19L ABWR Shutdown Risk Evaluation

The information in this appendix of the reference ABWR DCD, including all subsections, tables, and figures, is incorporated by reference with the following departures.

Figure 19L-3 Potential Path for Draining RPV Through Residual Heat Removal System (Pump On)

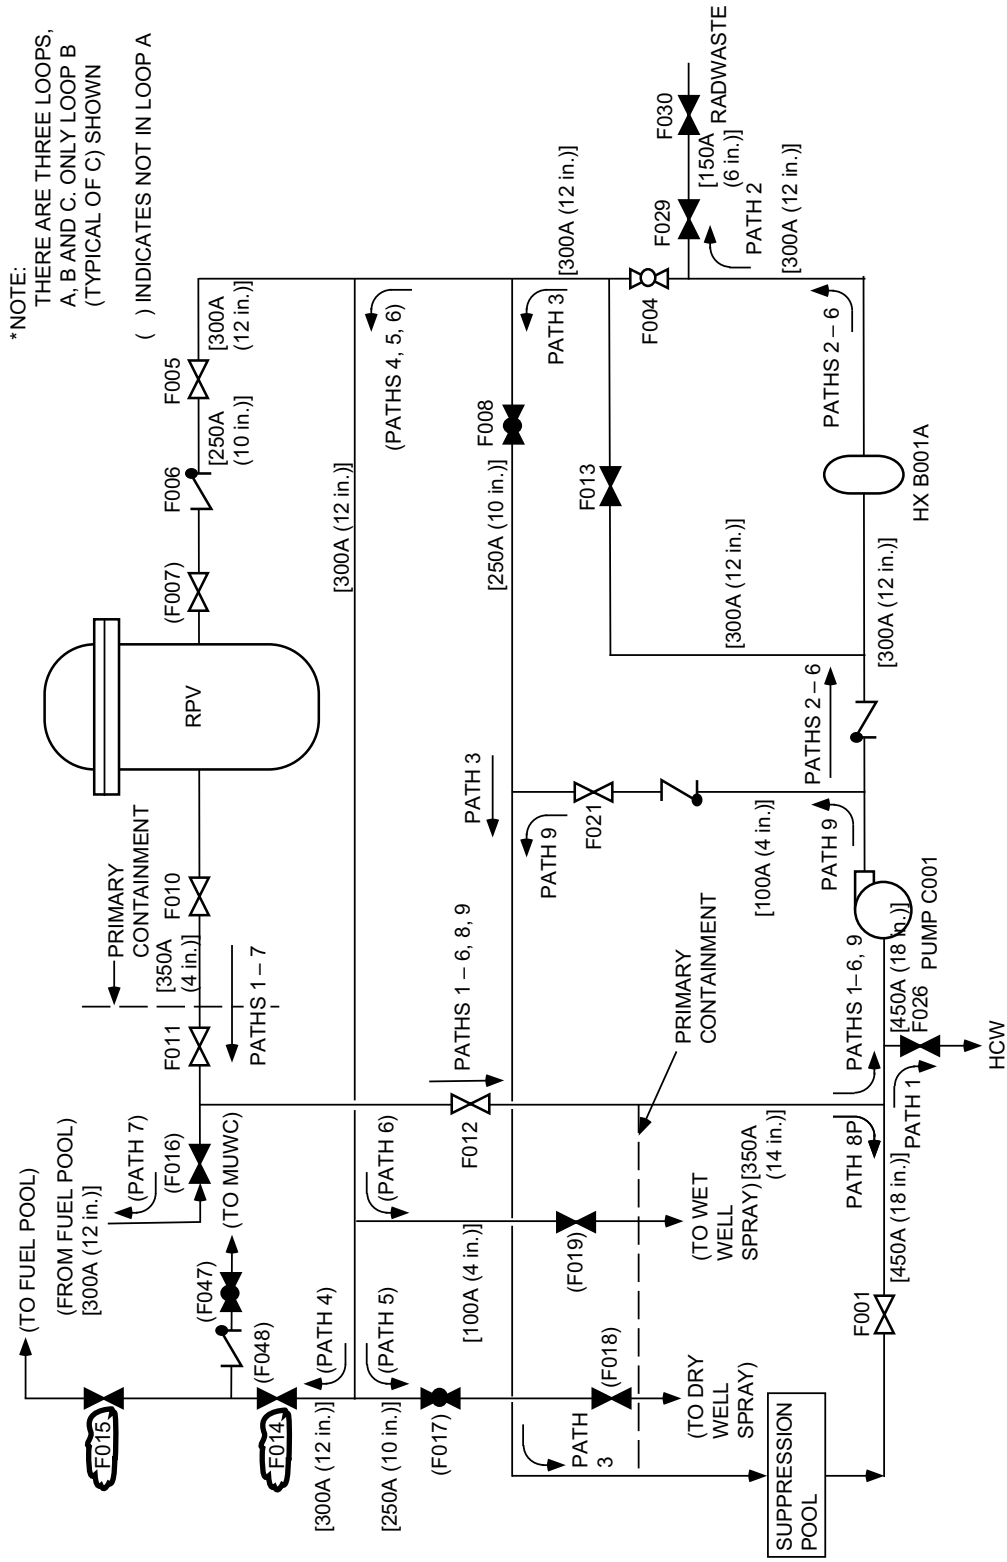
STD DEP T1 2.4-1 (Figure 19L-3)

STD DEP T1 2.4-1 (Figure 19L-3)

STD DEP T1 2.4-1

The ABWR residual heat removal (RHR) system is a closed system consisting of three independent pump loops (A, B, and C-where B and C are similar) which inject water into the vessel and/or remove heat from the reactor core or containment. Loop A differs from B and C in that its return line goes to the RPV through the feedwater line whereas loop B & C return lines go directly to the RPV. In addition, loop A does not have connections to the drywell or wetwell sprays. ~~or a return to the fuel pool cooling system.~~ However, for purposes of this analysis, the differences are minor and the three loops can be considered identical. The RHR system has many modes of operation, each mode making use of common RHR system components. These components are actuated by the operator; hence, the operation is subject to operator error which could potentially lead to drainage of the RPV. Potential paths for draining the RPV through the RHR system during operating Modes 4 and 5 are discussed below, summarized in Table 19L-8 and depicted in Figure 19L-3. Of the various modes of RHR operation it was judged that the potential for RPV draining was the greatest during the shutdown cooling mode. Therefore, the potential RPV draining paths start with the RHR in the shutdown cooling mode of operation. As will be shown by the following consideration and analysis, the probability of draining the RPV through the RHR system is negligibly low. Even if all the preventive and mitigative features fail, RPV draining will stop when the RHR shutdown cooling nozzle is uncovered at which point there is still 1.6 meters of water over the top of the active fuel.

STD DEP T1 2.4-1

The residual heat removal (RHR) design will have three RHR loops connected to the fuel pool cooling and cleanup system (FPCCS) instead of two for the reference ABWR DCD with normally closed inter-ties to permit additional supplemental cooling during refueling outages to reduce outage time.

Increasing the number of RHR loops connected to FPCCS from two to three results in a decrease in CDF, because it is an improvement of the outage management control for the fuel pool cooling system.
